ADDENDUM NO. 3

GARRETT COLLEGE MULTIPURPOSE FIELD SITE PREP

Date of Issue: December 30, 2022

SPECS JOB NO. 5593

1

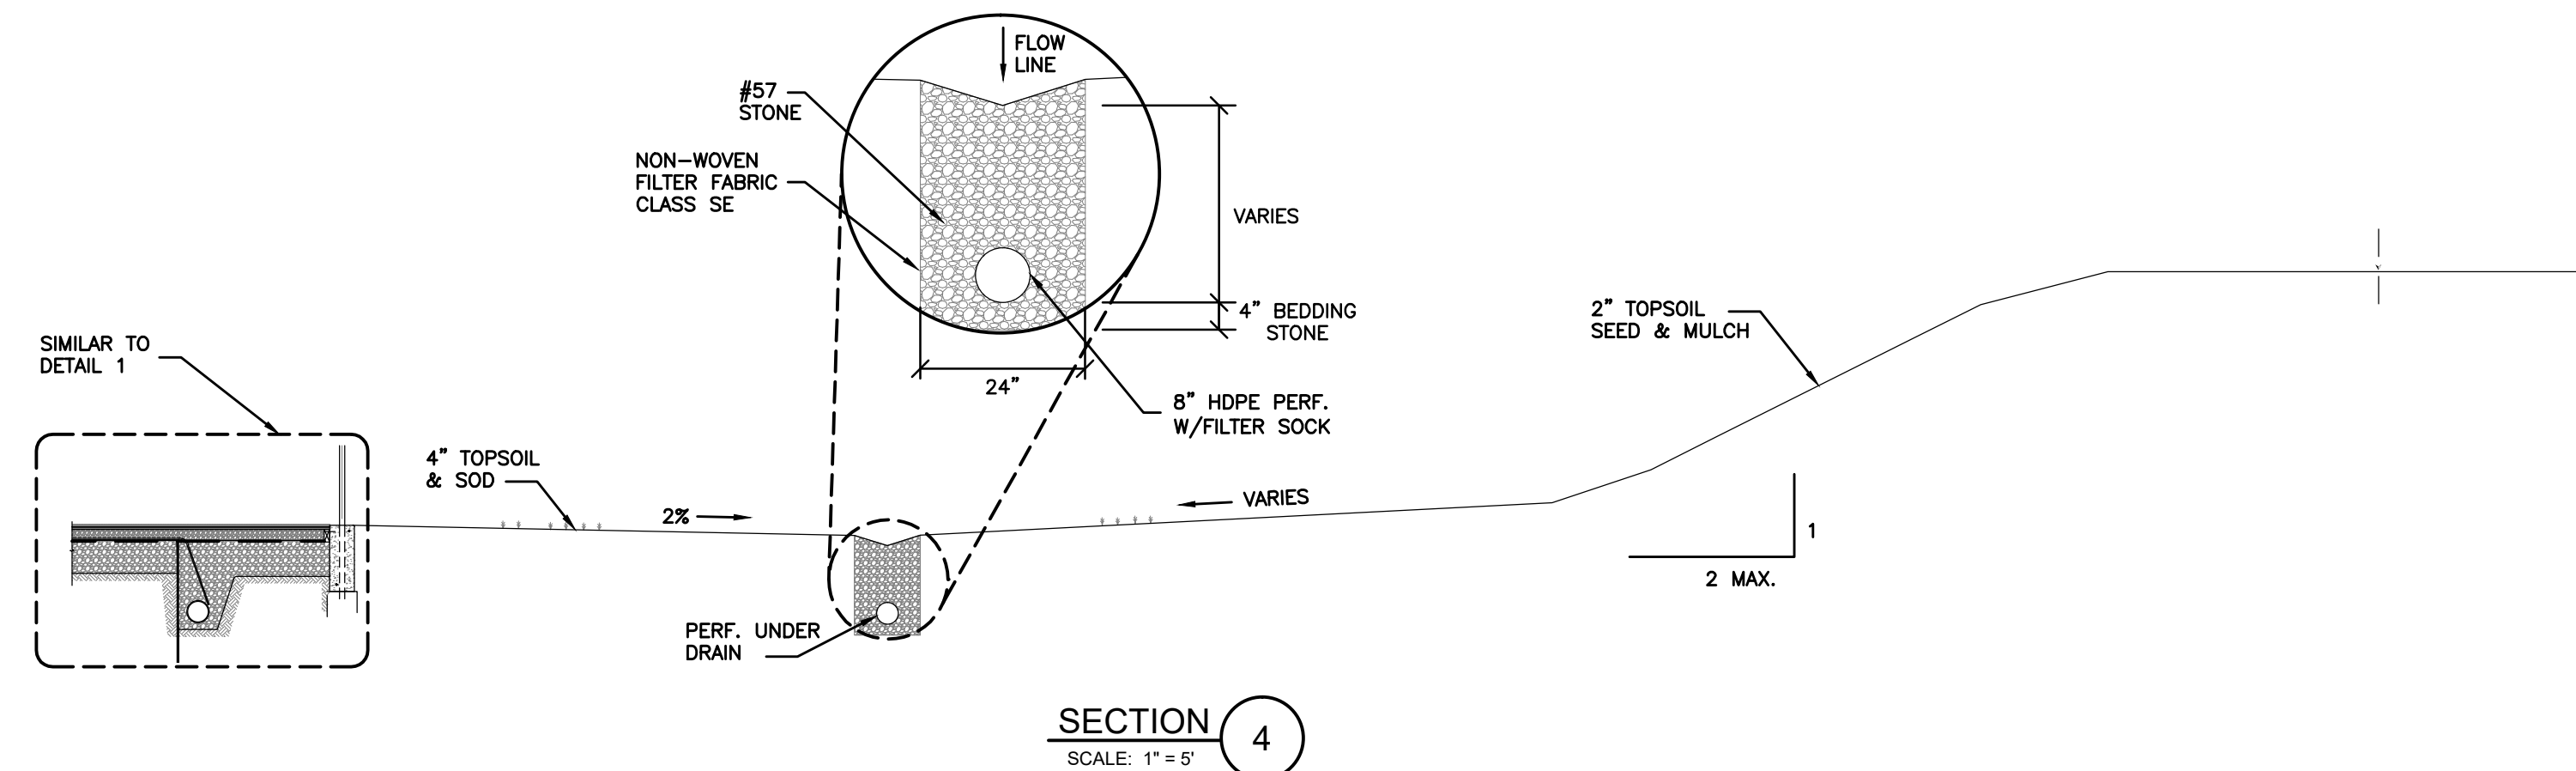
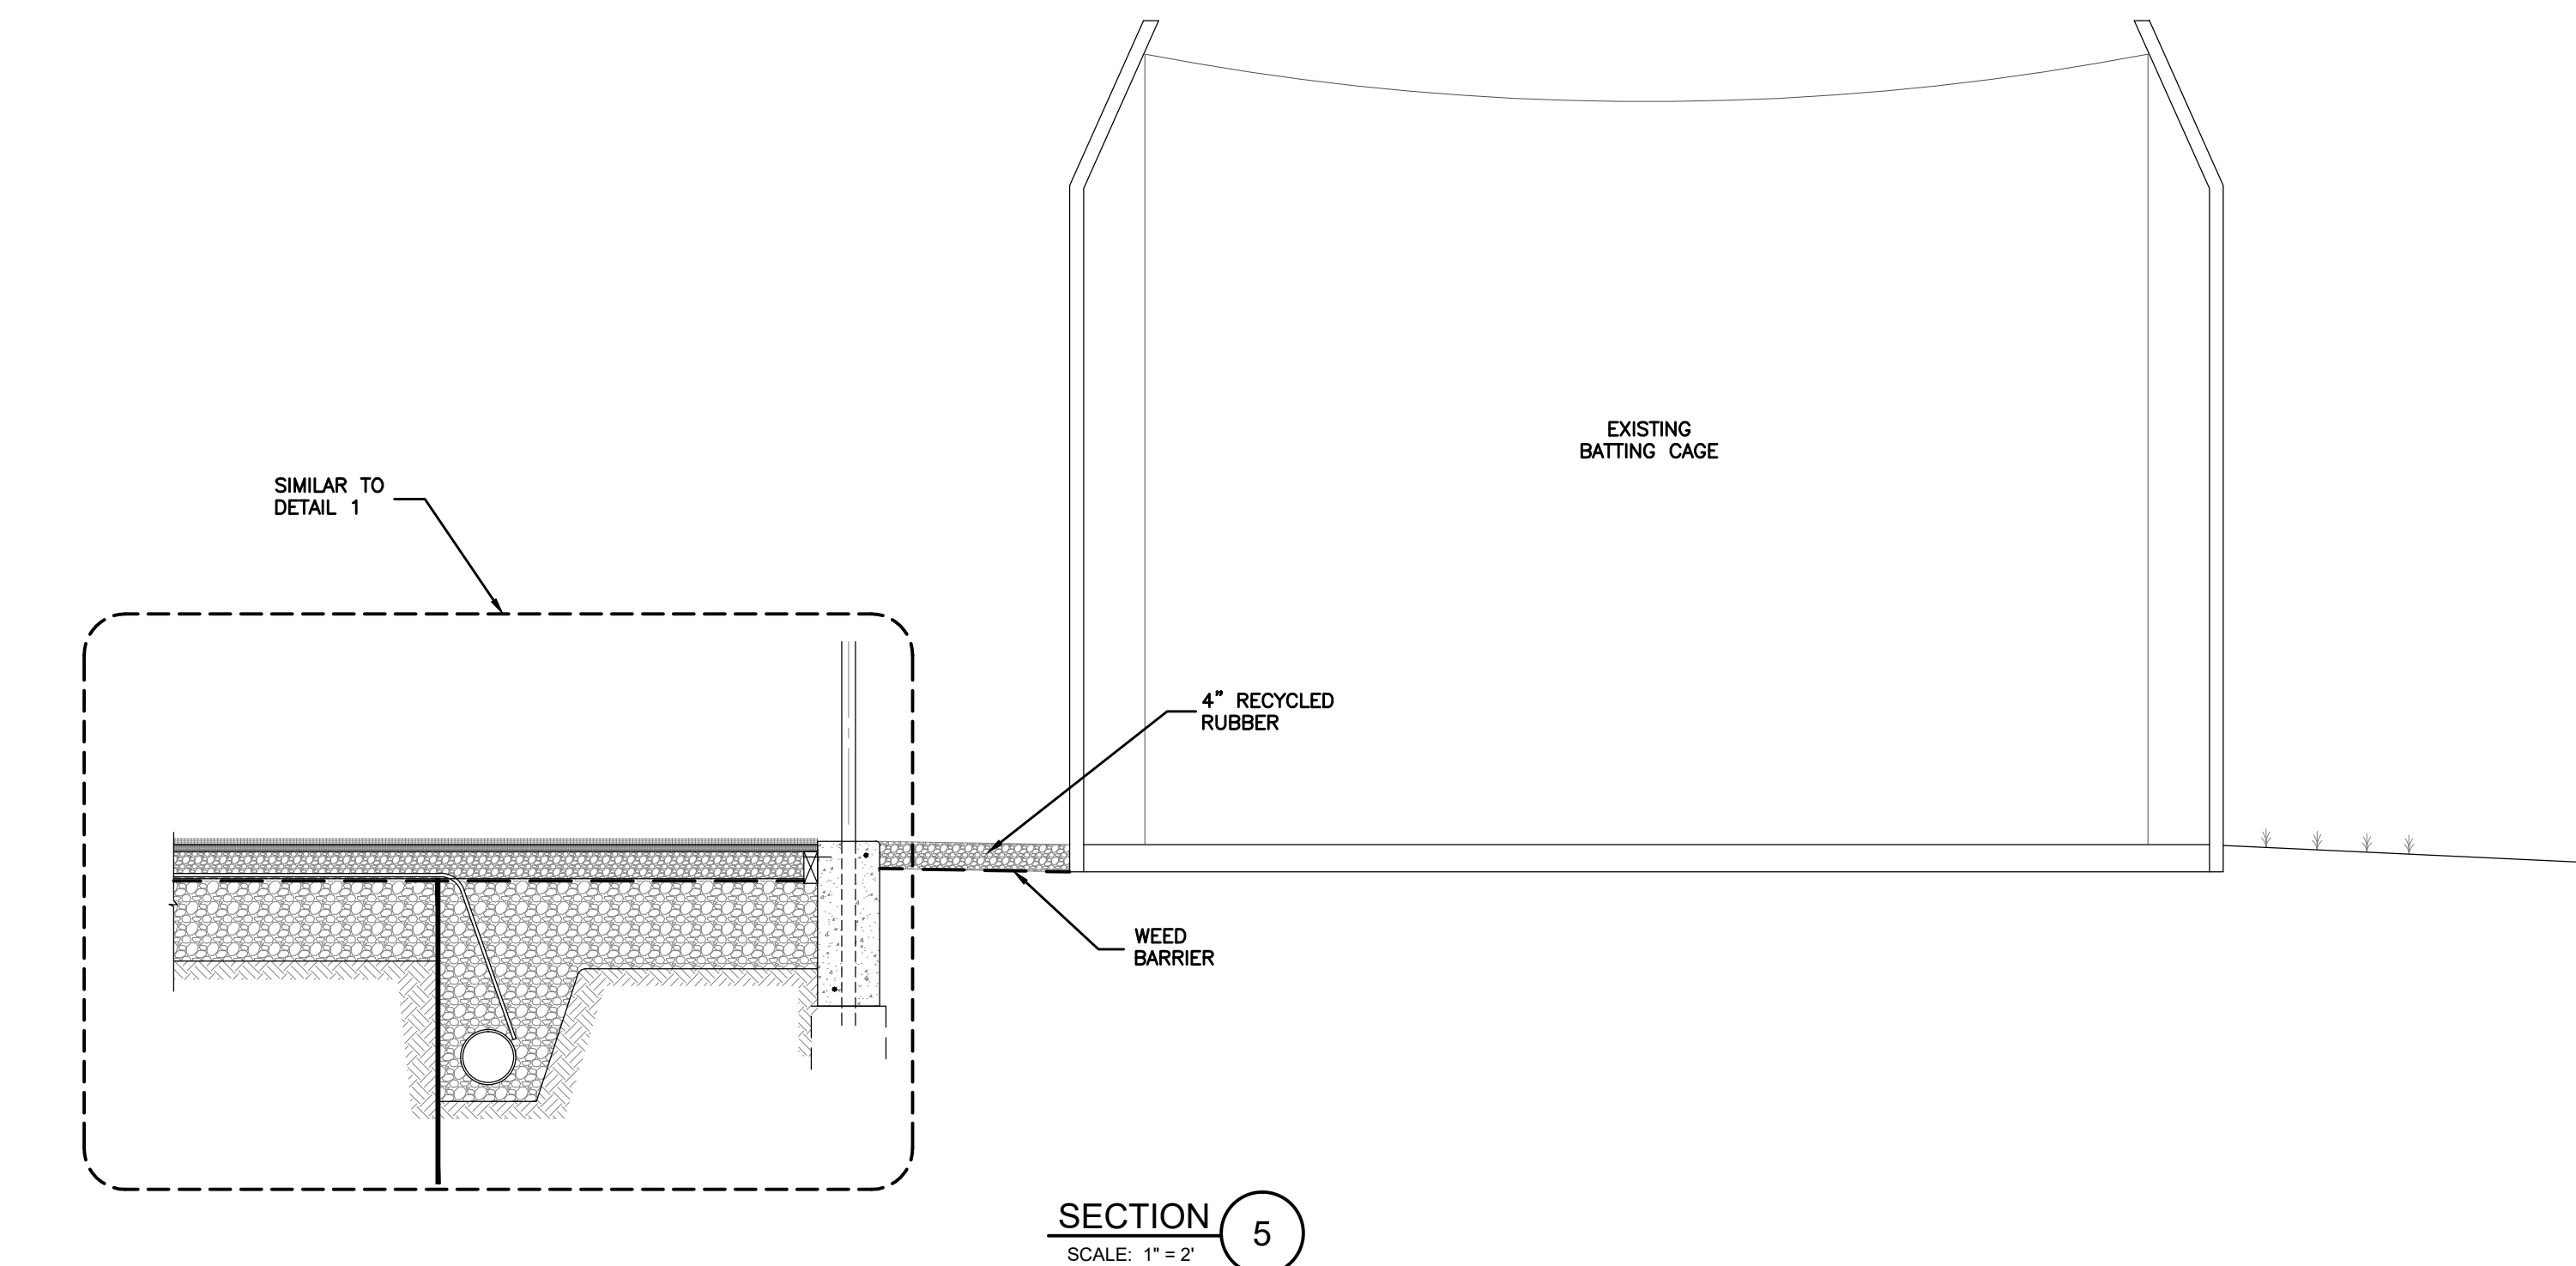
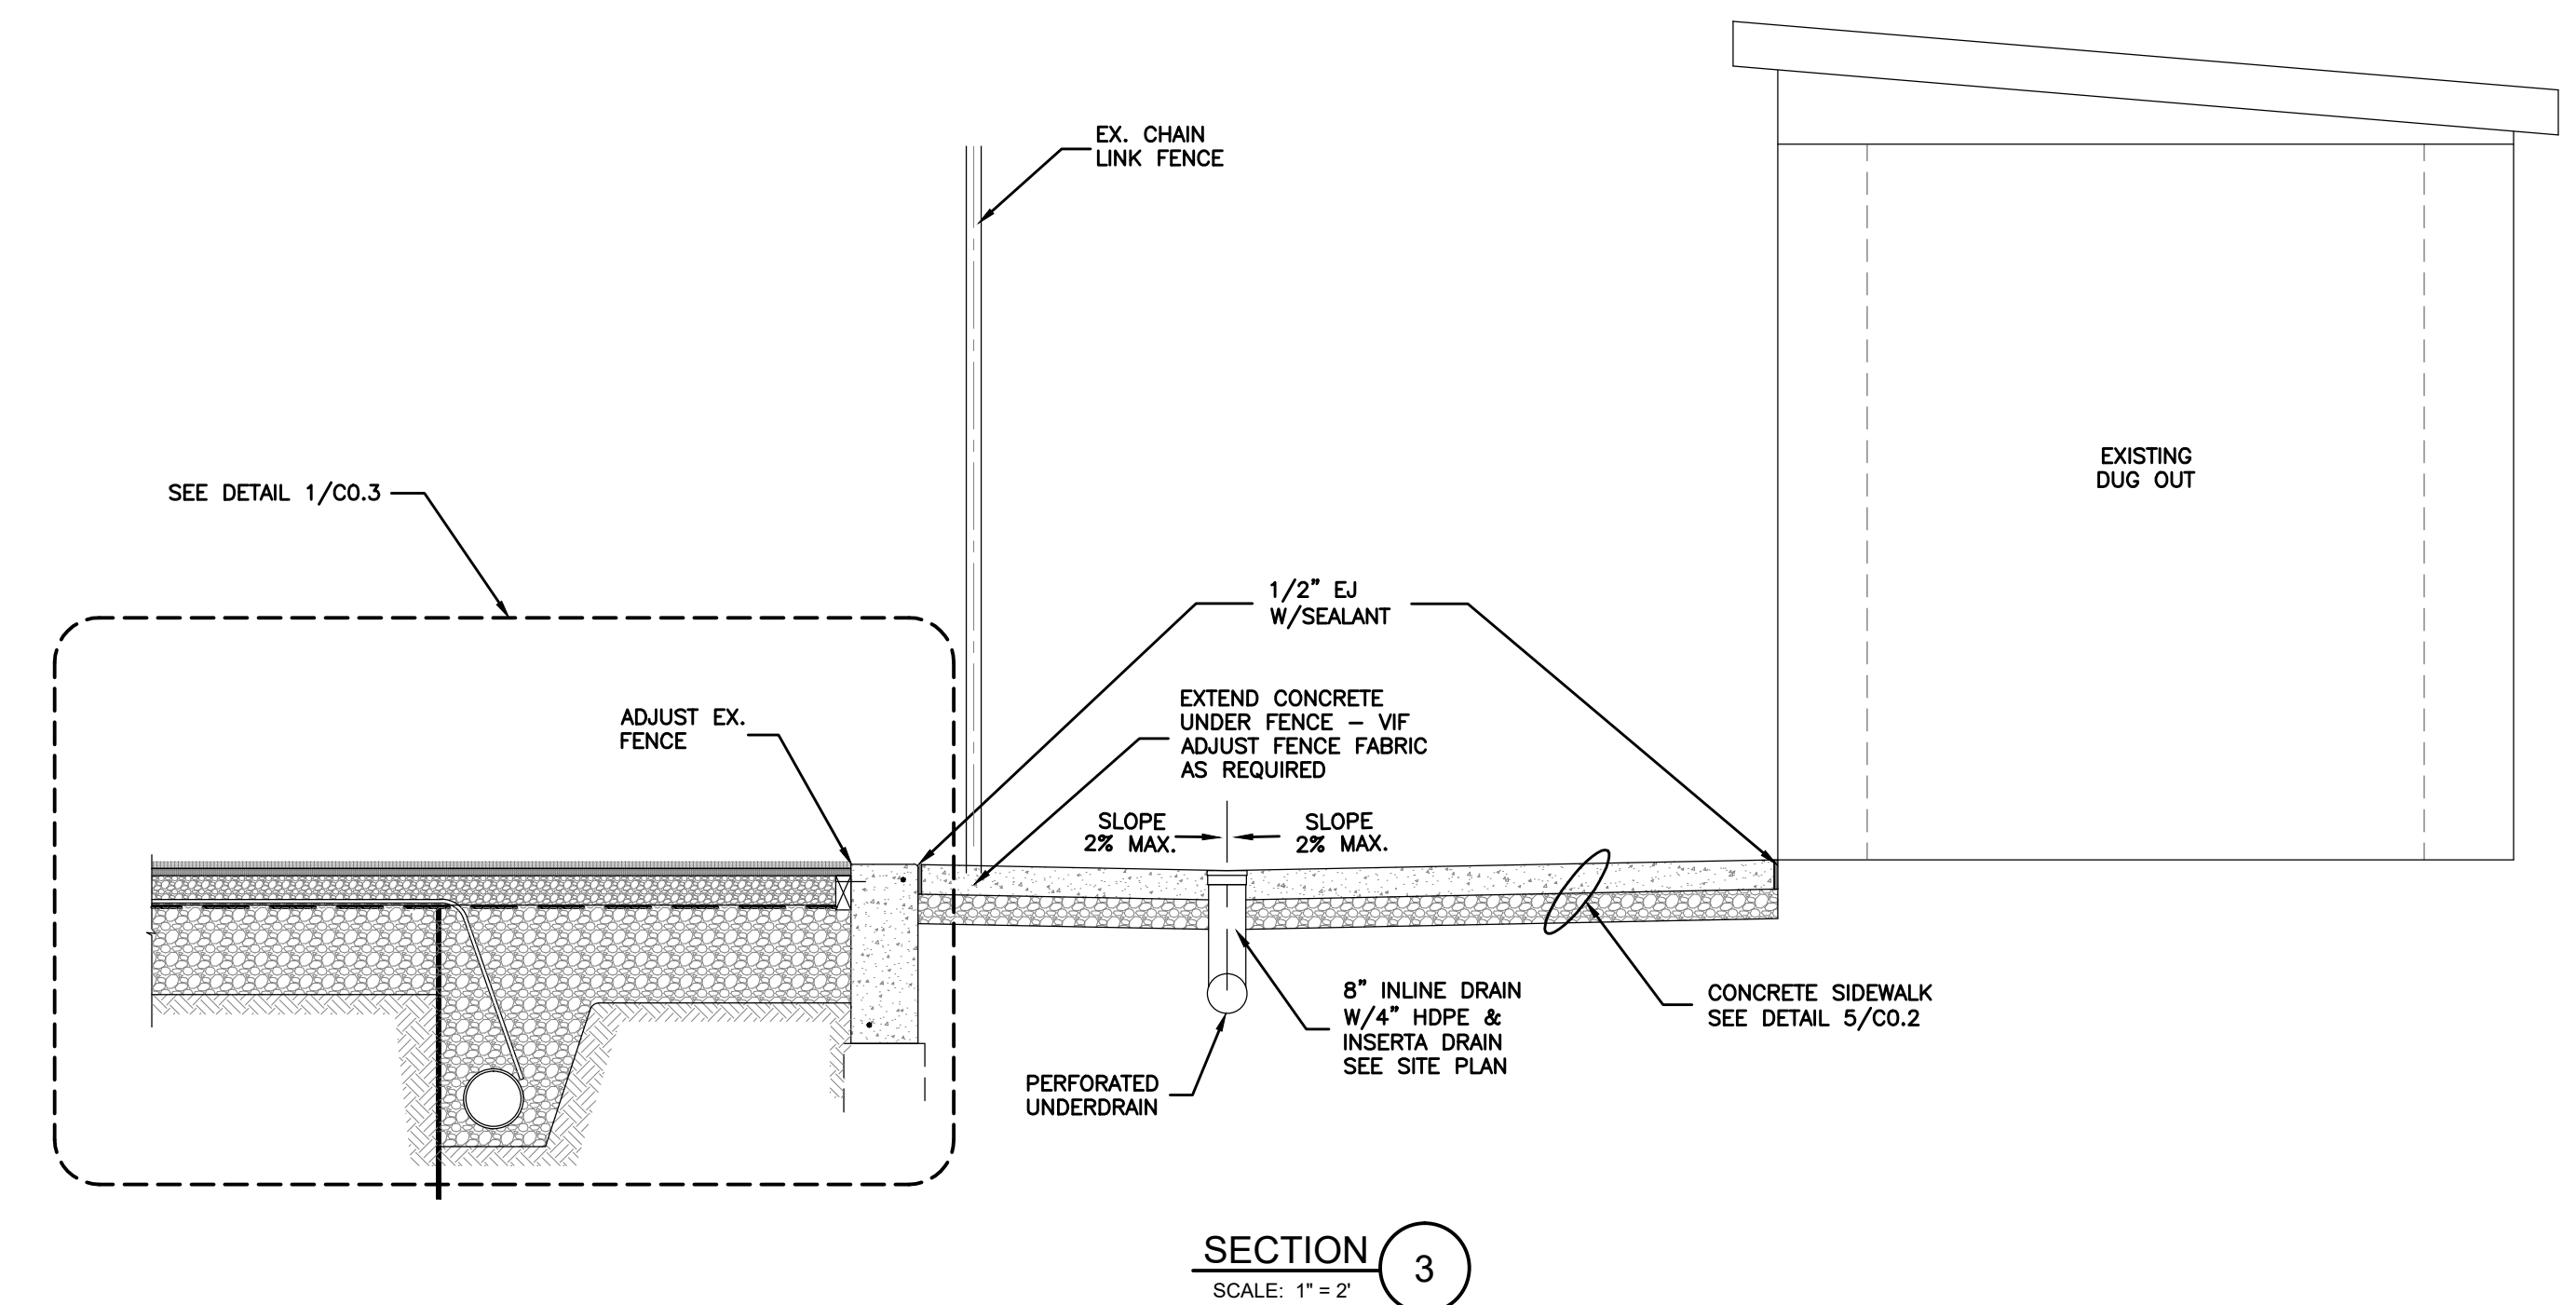
1. **REPLACE:** SHEET C0.0 with revised sheet. Change Table of contents and signature block. Drawings marked Revision 1.
2. **CLARIFICATION:** Detail 1/C0.3 and similar: Contractor may use sleeves for fence embedded in concrete. If sleeves are used, posts to be secured with non-shrink grout.

3. **REPLACE** Sheet C0.2 with revised sheet. Added invert in to Inlet I-14. Also revised detail 6 to reflect different French drain pipe sizes.
4. **REPLACE** Sheet C0.3 with revised sheet. Revised Detail 6.
5. **REPLACES** Sheet C2.0 with revised drawing. **CHANGE** diameter of French drain pipe from I-2 to I-1 from 8" to 12" HDPE. **ADD** 8" PERF UNDERDRAIN note for French drain pipe from I-2 to I-14.
6. **REPLACE** Sheet C4.0 with revised sheet. Sequence of Construction was revised.
7. **REPLACE** Sheet C4.1 with revised sheet. Sequence of Construction was revised.
8. **REPLACE** Sheet C5.2 with revised sheet including added profile between I-14 and I-2. Note pipe is deflected in the middle to drain both ways.
